REFERENCE: Manorwood Homes, Town of The Blue Mountains
Requirement for Noise Assessment
SDK Project P1206

SDK Environmental Consulting & Services (SDK) has prepared this letter for the Town of the Blue Mountains to provide an update with respect to noise impacts for the Manorwood Homes Development. The Site Plan Approval Application was submitted by Manorwood Homes to the Town of the Blue Mountains in April of 2021. It is our understanding that residential zoning is already approved for the subject property and that the Town requires an update with regard to noise impacts to ensure continued compatibility.

Figure 1 - Current 2021 Development Plan

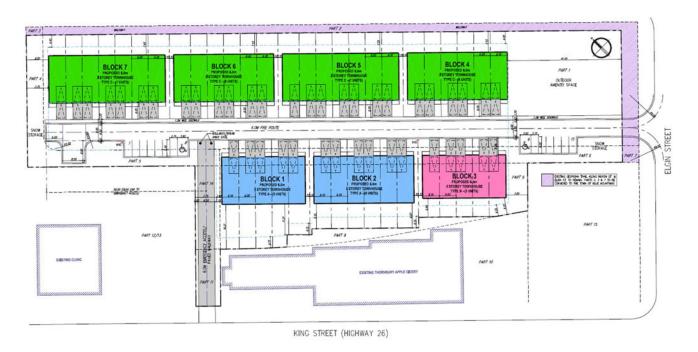
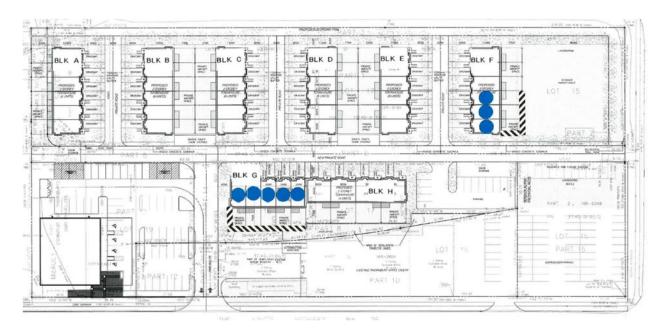
As shown the total unit count and building heights remains similar to the past design, but there are changes of potential significance for the newly positioned Block 3 (pink highlight in Fig 1). Block 3 would have potential sight lines to Hwy 26 (King St.) which we have further assessed using the same modelling approaches as conducted in past study and peer reviewed.

Figure 4 – Thornbury Village Cider & Brew House Noise Source Location Plan

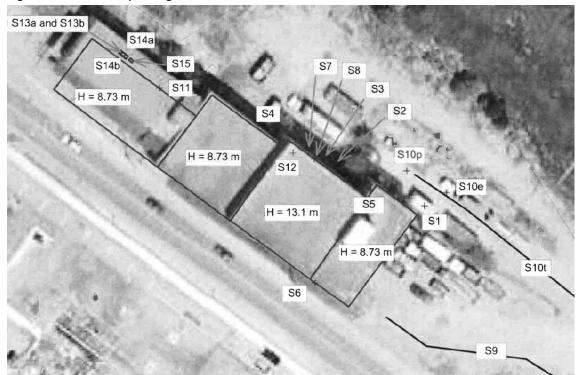
Many of the sources identified in the table are chillers located outside of the facility, along the north façade of the building and immediately adjacent to the proposed development. These chillers have a sound power level up to 89.5 dBA. These would be considered to be loud and significant sources.

In addition, the report states that  $CO_2$  is used to package some beverage products. Bulk  $CO_2$  deliveries are made by truck and the equipment used to off-load bulk  $CO_2$  is inherently loud. Bulk  $CO_2$  unloading was listed as having a sound power level of 109 dBA.

Tonality was not identified for the CO<sub>2</sub> unloading activity. From our experience truck unloading of compressed gas is considered tonal and would require adding a +5 dB tonal penalty to the noise source. Tonal noise is any sound that has a pronounced audible tonal quality such as a whine, screech, buzz, or hum.

The CO<sub>2</sub> unloading source is currently positioned to be approximately 10 m from the proposed residential units and would have a potential noise impact above 80 dBA at the proposed units. Bulk CO<sub>2</sub> calculations in the report used a reduction of 10 dB due to a reduced operating time (running 6 minutes for any given hour) which should be confirmed since the report also stated the source operates continuously (60 minutes for any given hour).

Figure 6 – Thornbury Village Cider & Brew House Sensitive Points of Reception

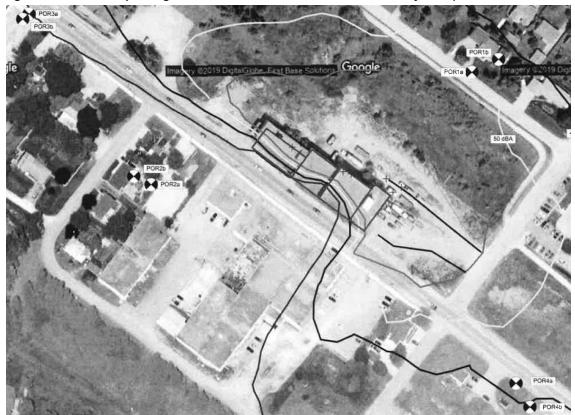
The DRAFT Acoustic Assessment Report assessed noise impacts at four (4) existing residential properties located near the facility as identified in Figure 6. Notably the report did not assess compliance at the proposed development.

The vacant land which represents the subject property for the proposed development was not assessed in the noise report, which is a critical omission. The official Thornbury zoning plan, included in the DRAFT Acoustic Assessment Report, clearly identifies the plot of land of the proposed Manorwood Homes development as residential. EASR guidance states that vacant land zoned for residential use must be considered a point of reception for noise evaluation.

The report misidentified the appropriate noise criteria for the area. The Class 1 noise criteria is not reasonable and should be identified as Class 2, or otherwise confirmed with a detailed traffic study to justify Class 1 (which is intended for large urban areas). The 2013 Noise Feasibility Study and associated Peer Review both concurred on the Class 2 designation.

The source heights for some of the noise sources are unrealistically short in elevation, sometimes only 1.0 m or less above grade. This will under predict the potential for impact.

In consideration of these findings, significant revisions are warranted for the DRAFT Acoustic Assessment Report to ensure compliance is achieved at the proposed development.
